PUBLIC HEARING/WORKING SESSION MEMORANDUM

PETITION #148-15 AND (2)

180 WELLS AVENUE

Proposal of INTRUM CORPORATION, for a SPECIAL PERMIT/SITE PLAN APPROVAL to construct a 60,565 square-foot addition to be connected to the existing office building, as well as a one-story parking deck, and to redesign existing parking facilities increasing the number of parking stalls from 215 to 378. Accompanying the petition is a request to amend the Deed Restriction adopted by Board Order #276-68(3), dated November 18, 1968, and subsequent amendments be further amended or waived to increase the Floor Area Ratio from 0.25 to 0.53, which exceeds the maximum of 0.25, to waive the minimum 40% open space requirement, and to allow a greater percentage of square footage in the office park to be dedicated to office space.

I. WELLS / NAHANTON - CONES / PHASING / VOLUMES

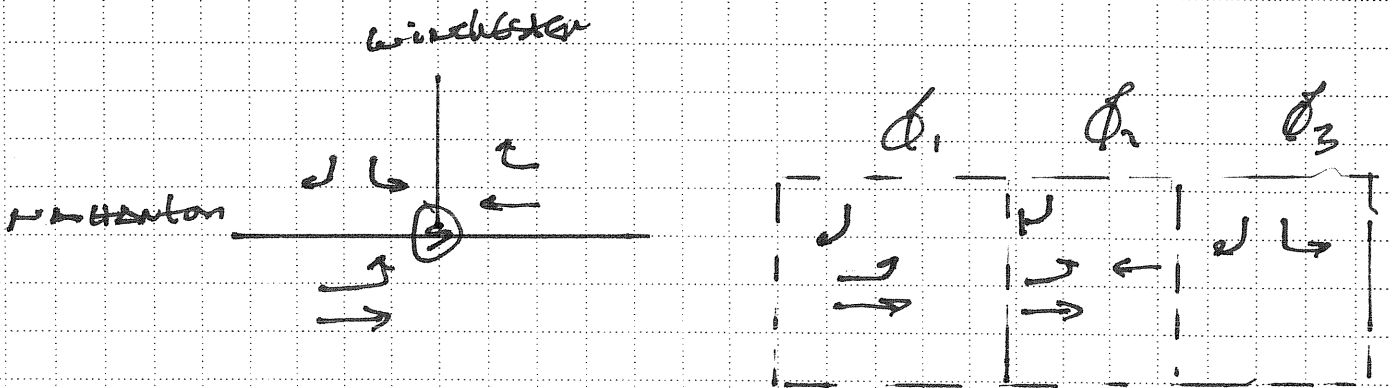
Signal Phase:	ϕ_1	ϕ_2	ϕ_3
Critical Volume: (No Build)	43 (→)	← 983	21 (↘)
Site Traps (New)	3	16	(0) 19
	<u>437</u>	<u>999</u>	<u>21</u>

CAP: $\frac{C.L.V. \text{ New}}{1,425} = \frac{19}{1425} = 1.3\%$

PM Peak - NANTUCKET/WINCHESTER

Critical Volume: (No Build)	ϕ_1	ϕ_2	ϕ_3
	414 (→)	← 503	62 (↘)
Site Traps:	19	3	0 22
	<u>433</u>	<u>506</u>	<u>62</u>

CAP = $\frac{C.L.V. \text{ New}}{1,425} = \frac{22}{1,425} = 1.5\% \approx \underline{\underline{2\%}}$

A.M. PEAK - WELLS @ NANTUCKET

SIGNAL PHASE:	ϕ_1	ϕ_2	ϕ_3	ϵ
Critical Volume: (NO-BUILD)	314	920	146	
SITE TRIPS (NEW):	37	0	11	48
	<u>351</u>	<u>920</u>	<u>157</u>

$$CAP = \frac{C.L.V. \text{ NEW}}{1.425} = \frac{48}{1.425} = \underline{\underline{3.4\%}}$$

P.M. PEAK - WELLS @ NANTUCKET

ϕ_1	ϕ_2	ϕ_3	ϵ
Critical Volume: (NO BUILD)	243	617	709	
SITE TRIPS :	7	0	75	82
TOTAL :	<u>250</u>	<u>617</u>	<u>784</u>

$$CAP = \frac{C.L.V. \text{ NEW}}{1.425} = \frac{82}{1.425} = 5.8 = \underline{\underline{6\%}}$$

Figure 6

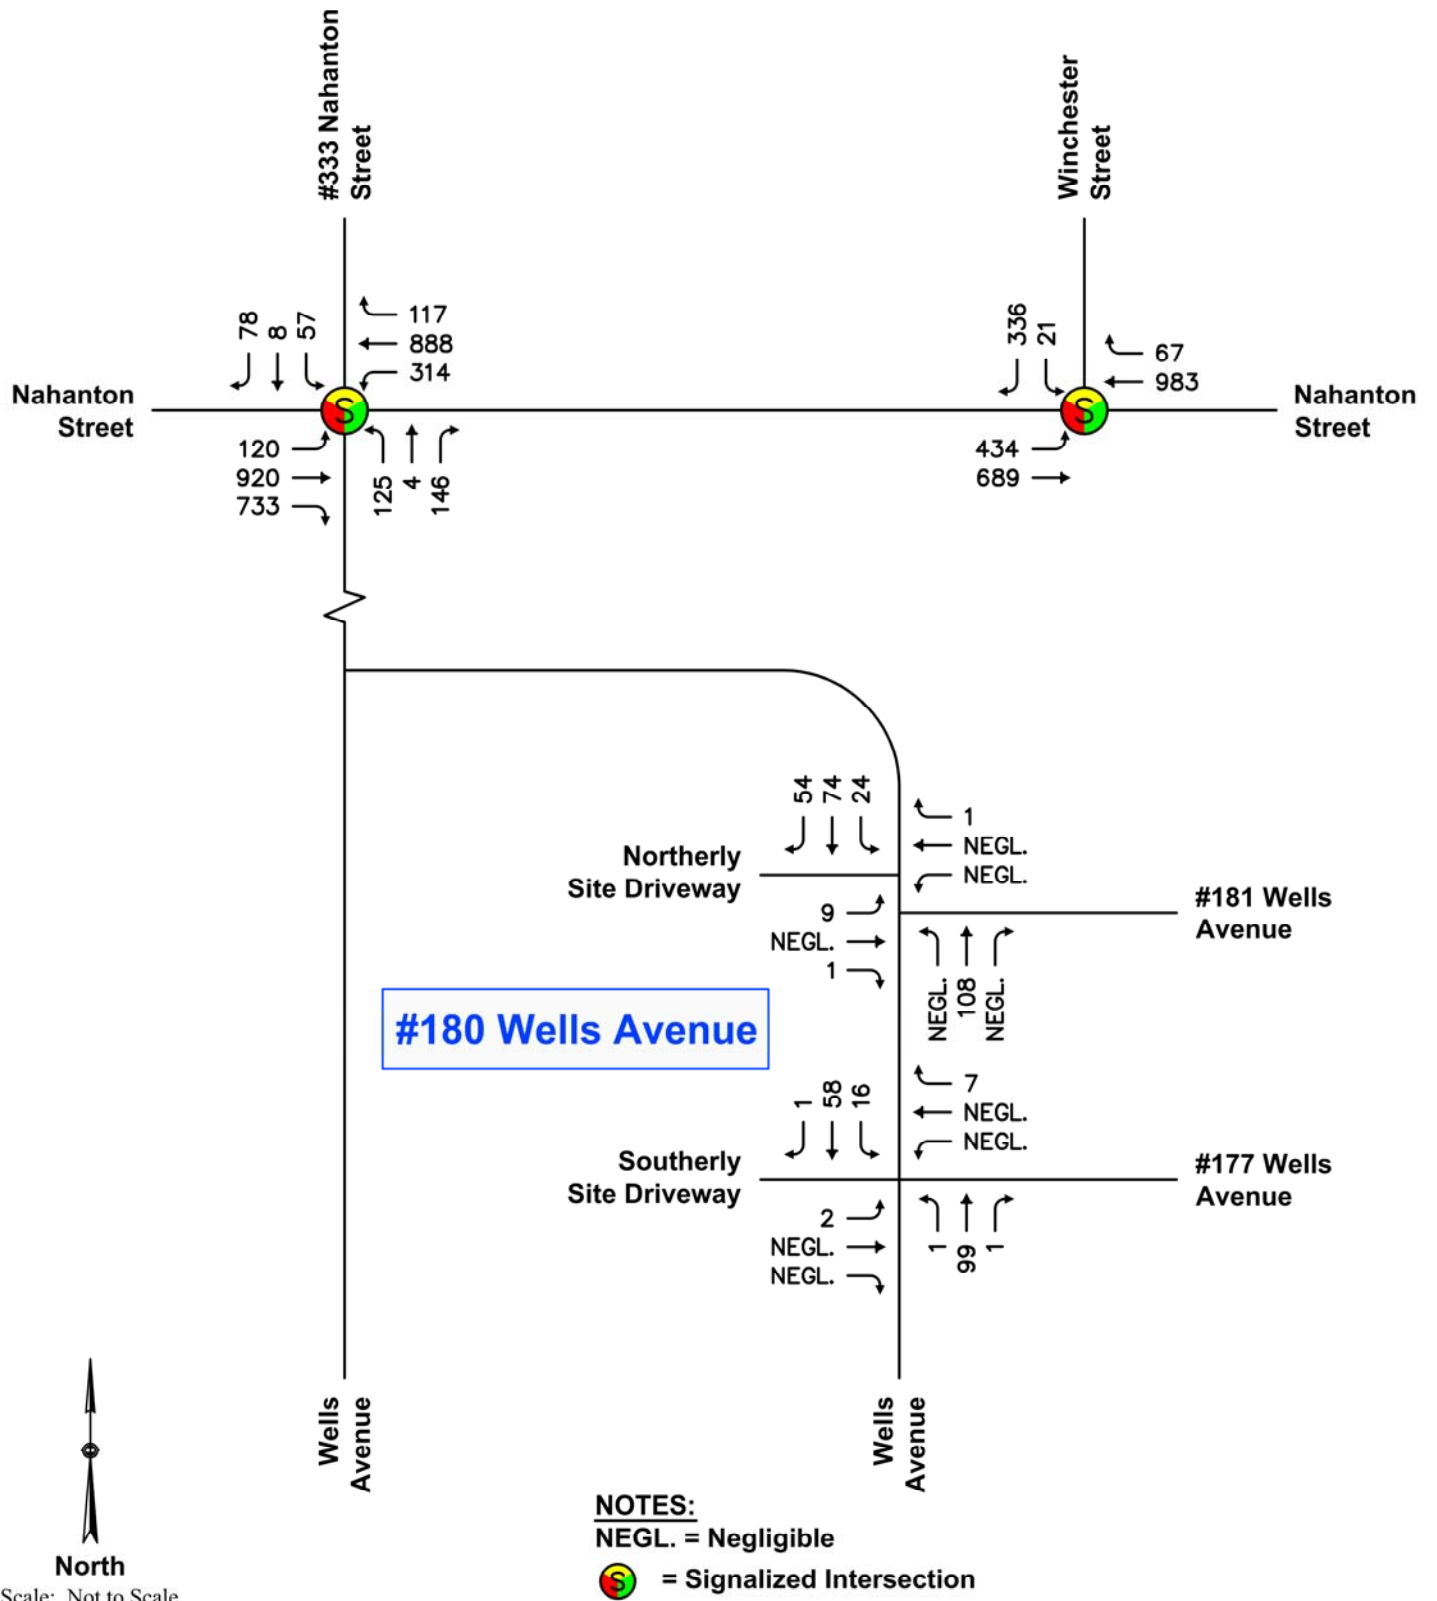
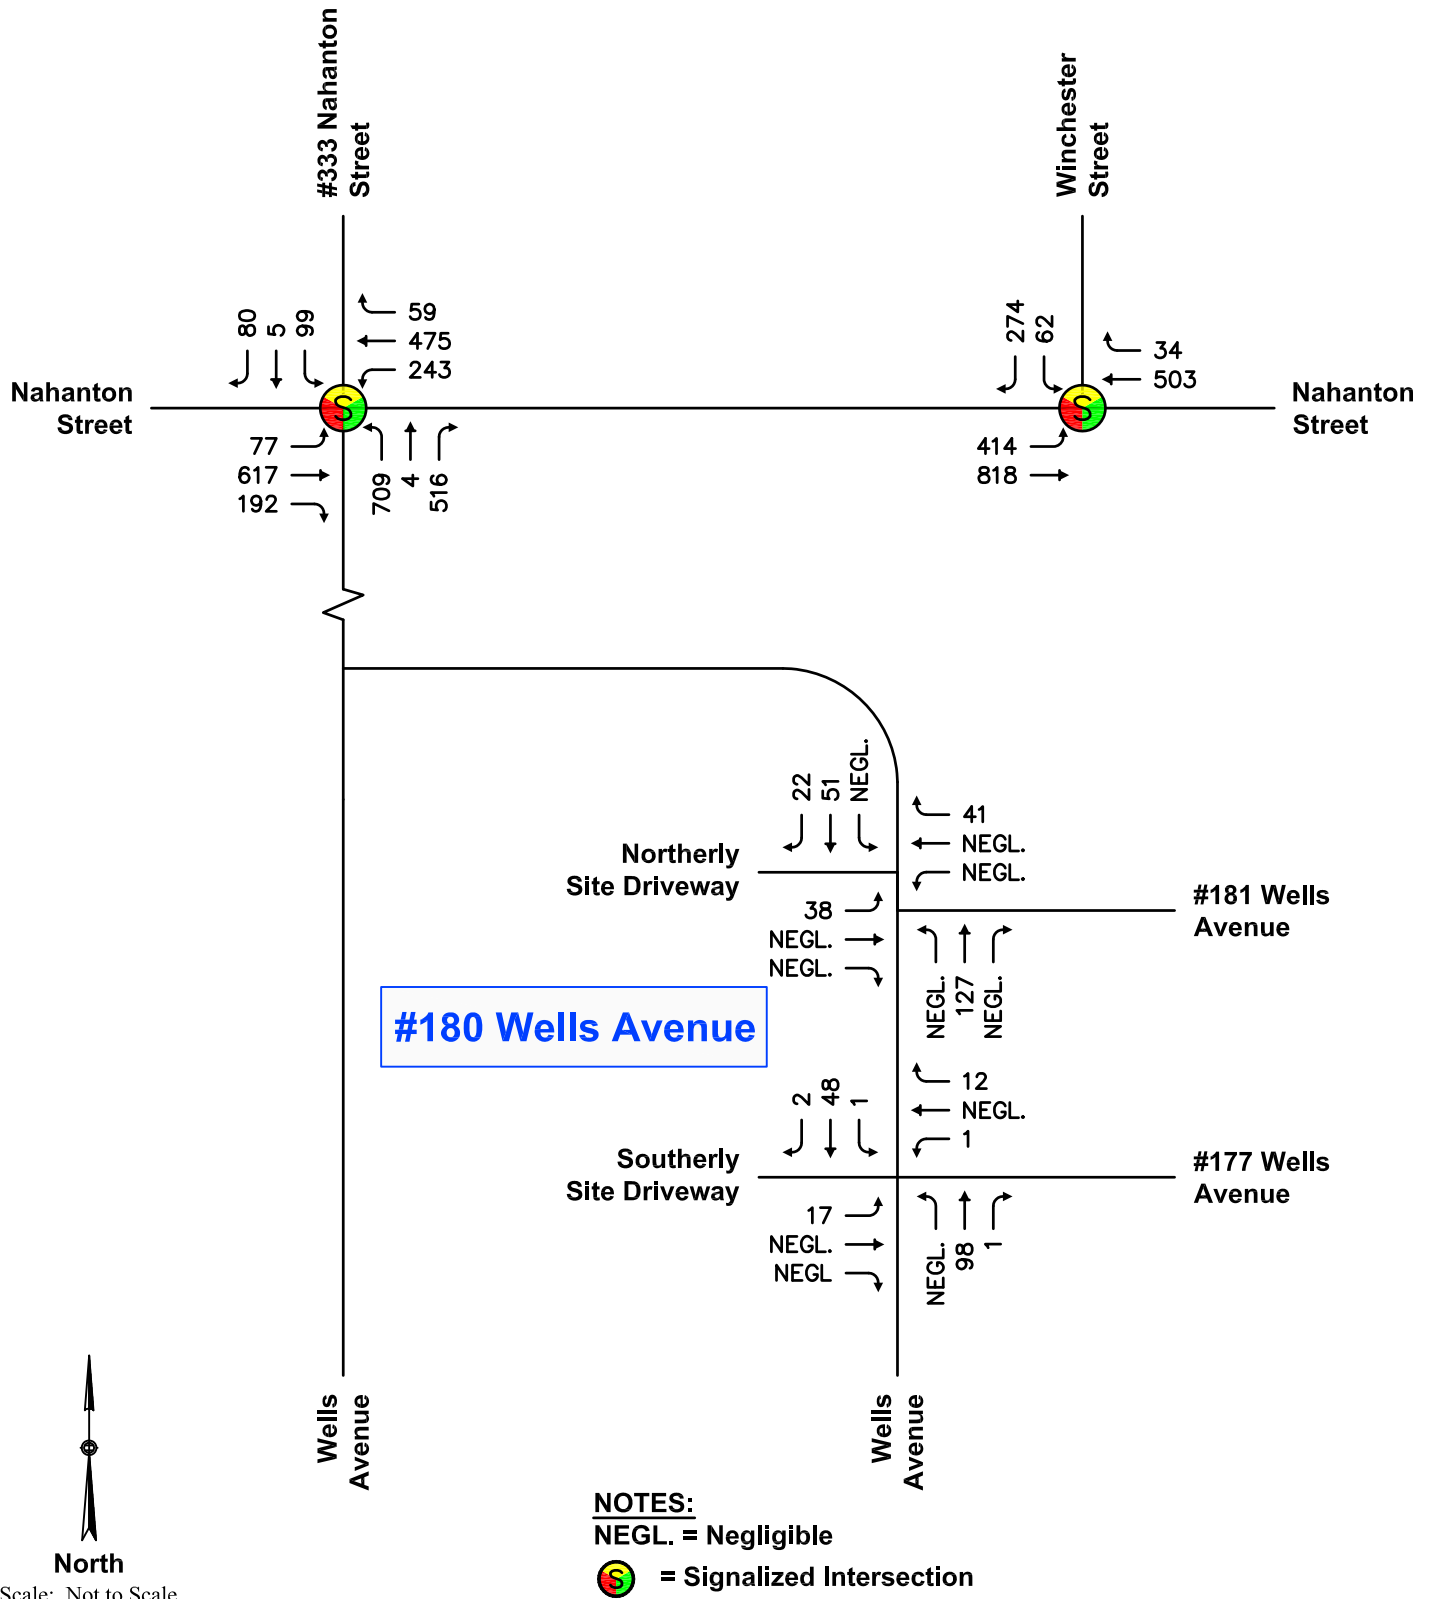
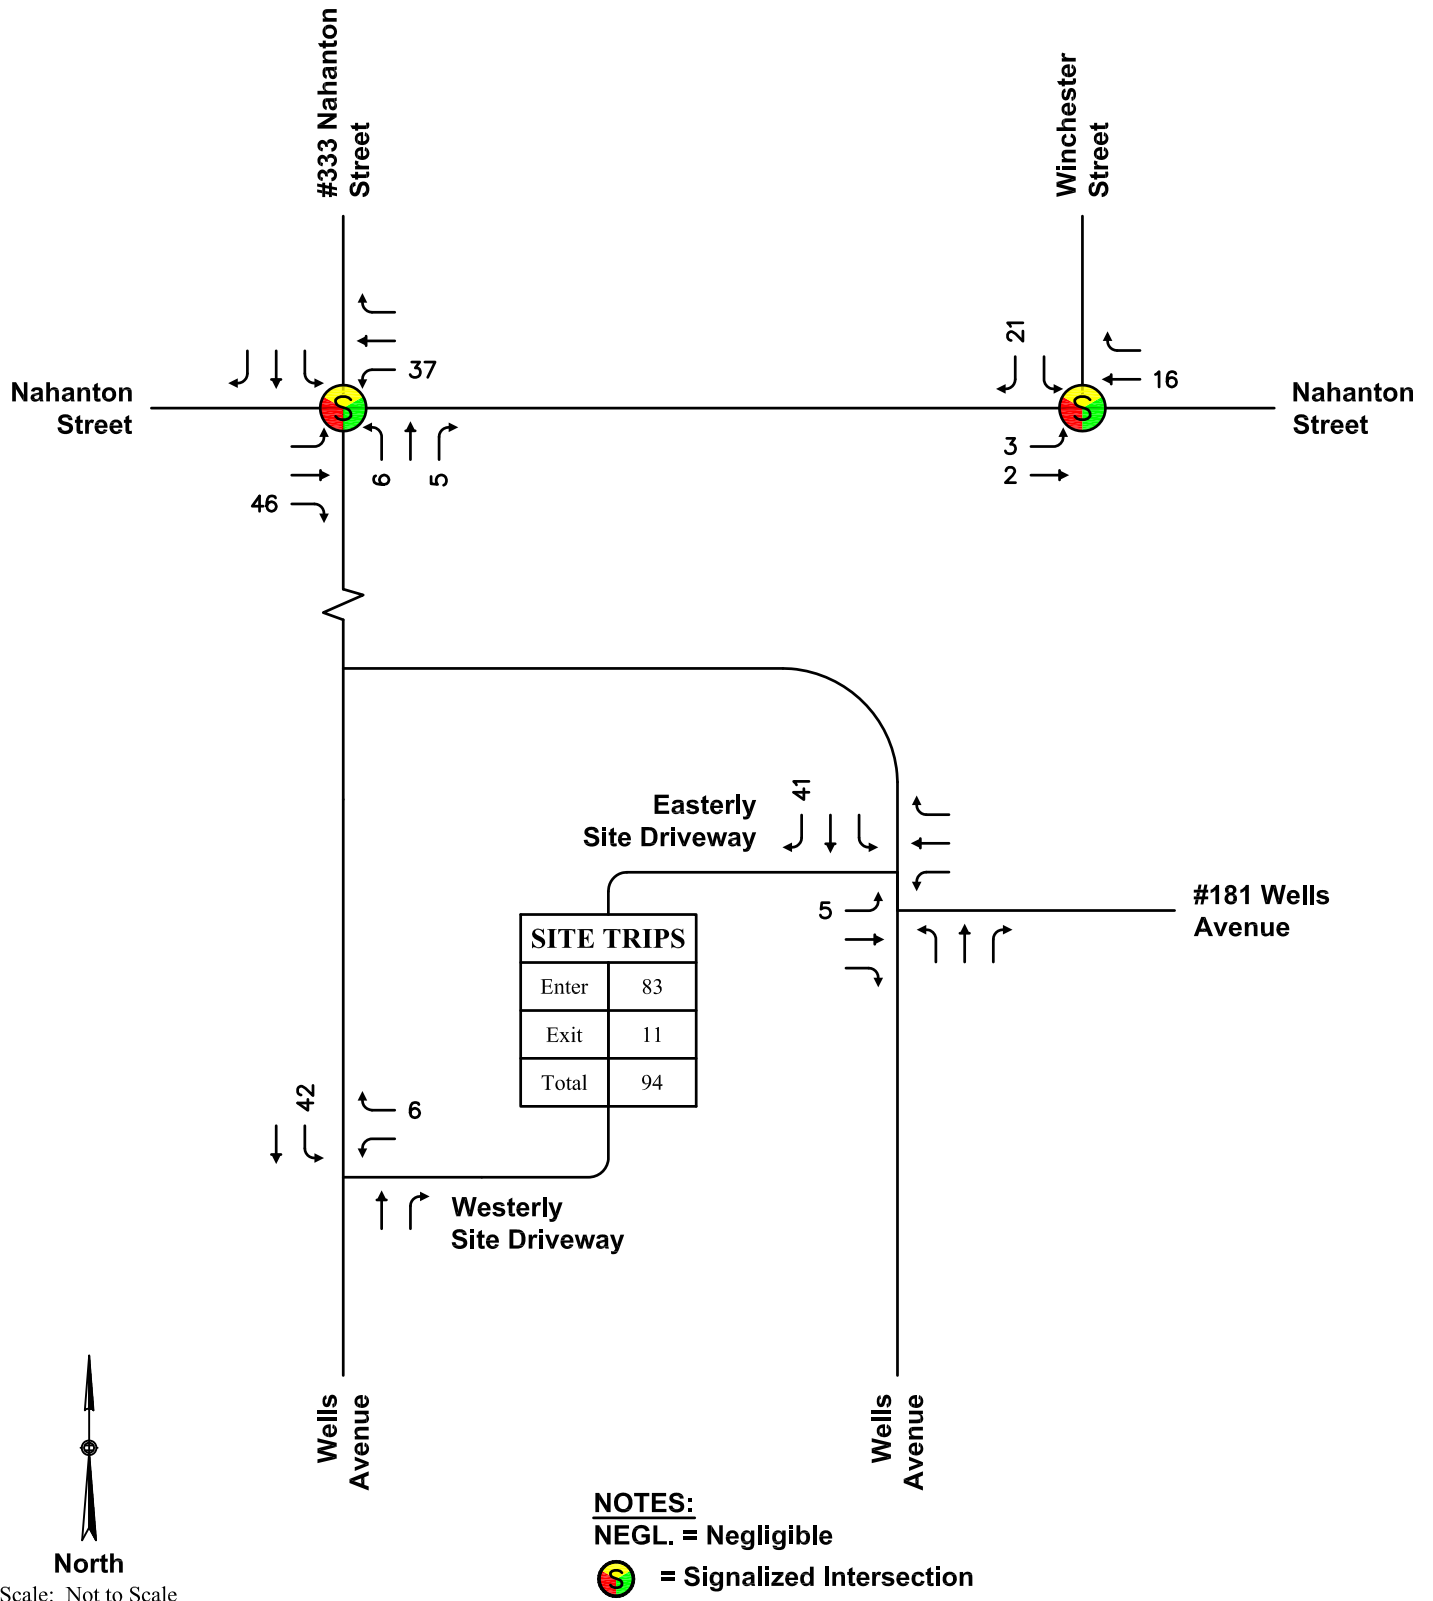
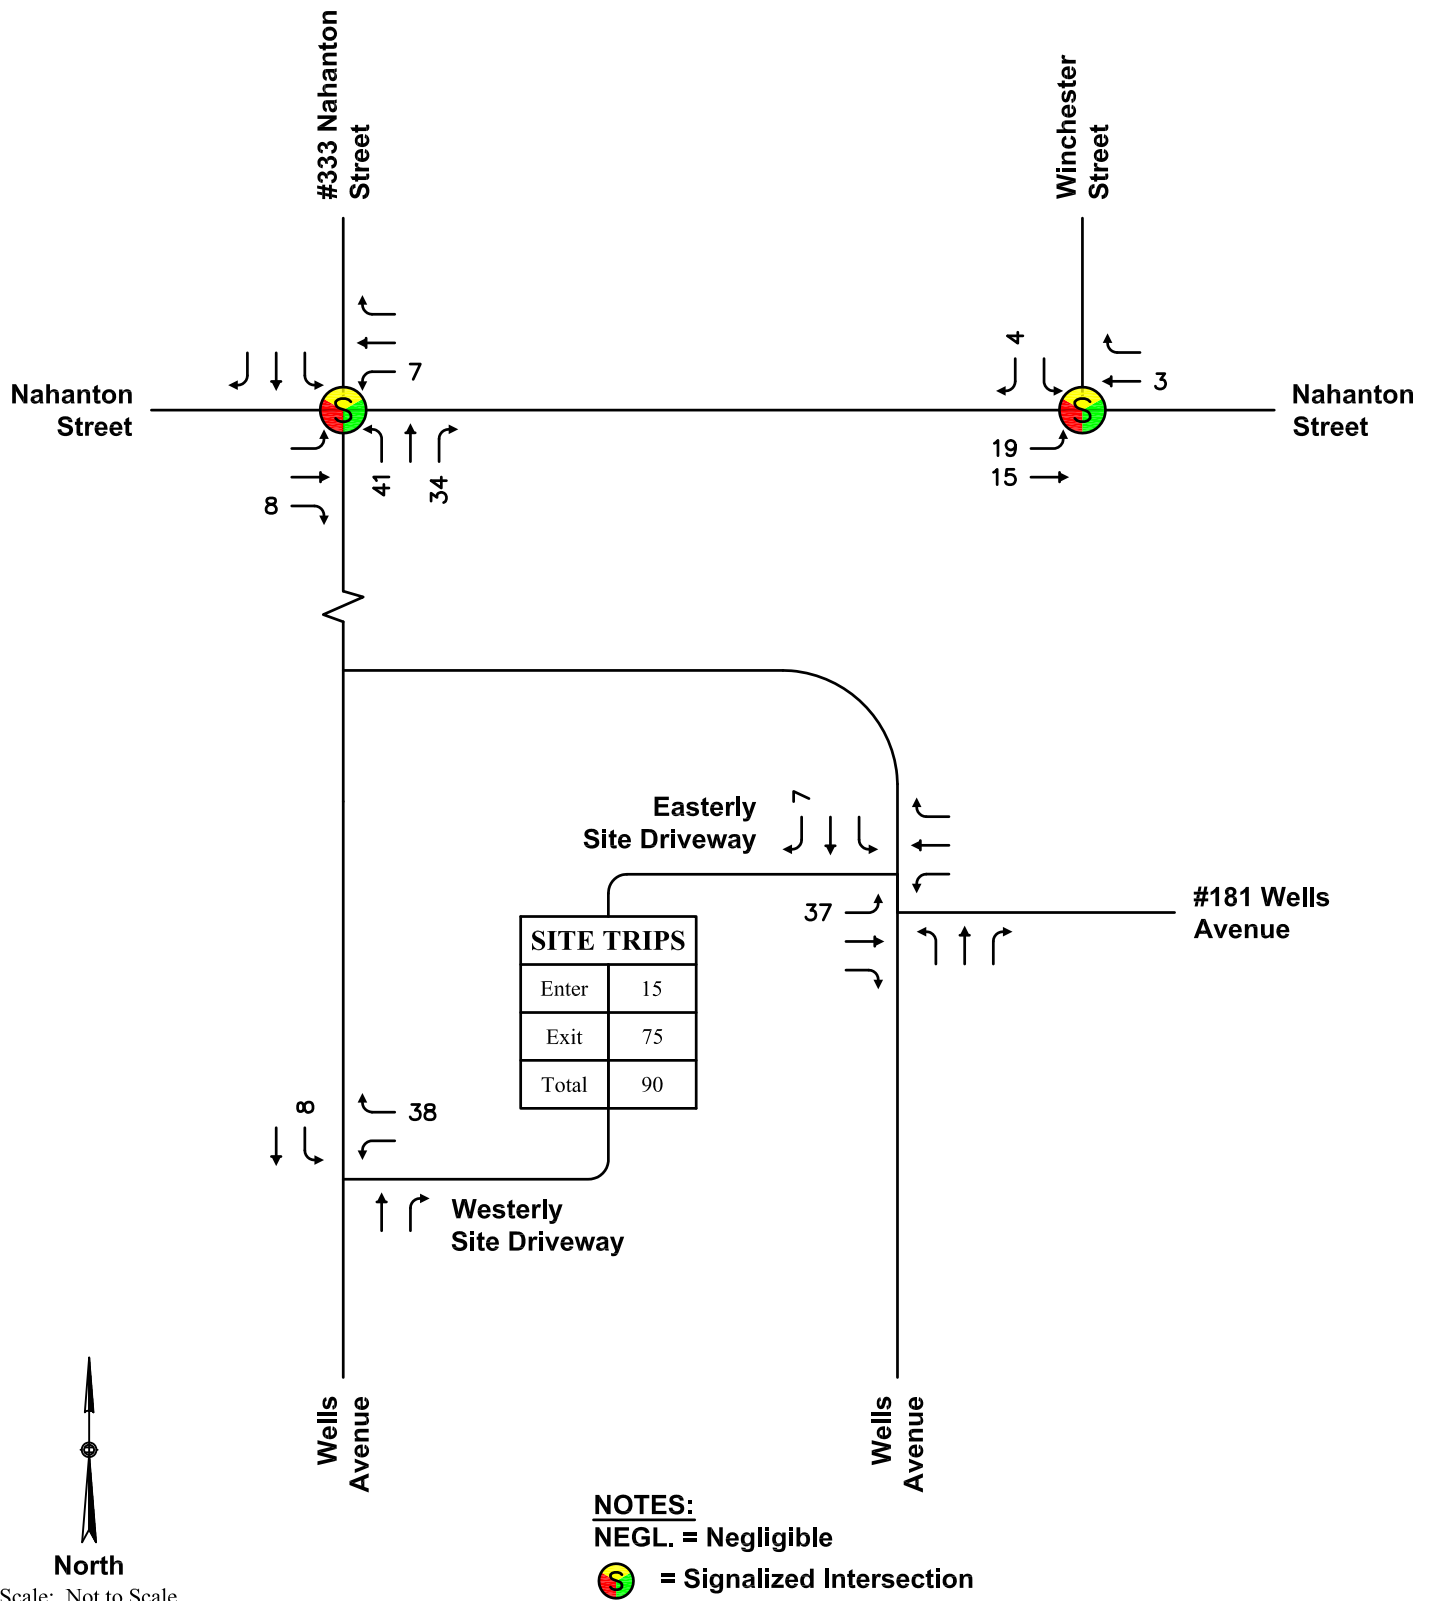
(SEE FIG'S 6, 7, 9, 10 FOR VOLUMES)

(SEE FIG'S 6, 7, 9, 10 FOR VOLUMES)
